Intel[®] Ethernet Controller I210

Specification Update

Revision 2.8
332763-012

Figure 1-1. Explanation of Top Markings for A3 Stepping

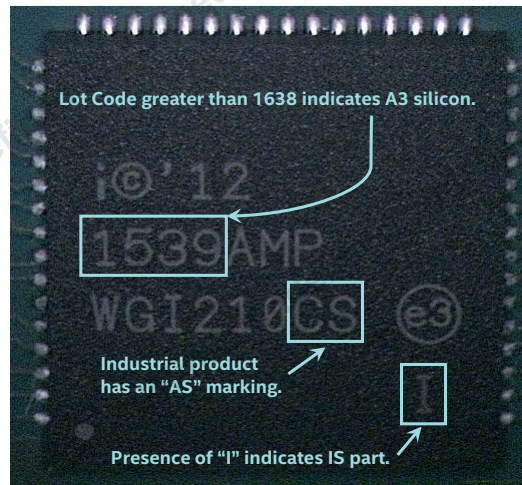
The A3 stepping only applies to the Fiber (IS/CS/CL) products. The A3 stepping can be identified by the Fab Lot Trace Code marking on the package or by the iNVM contents.

- Fab Lot Trace Codes starting with 1638 or greater are A3 devices.
- Bit 1 of INVM_DATA[61] (0x12214) is 1b on A3 devices.
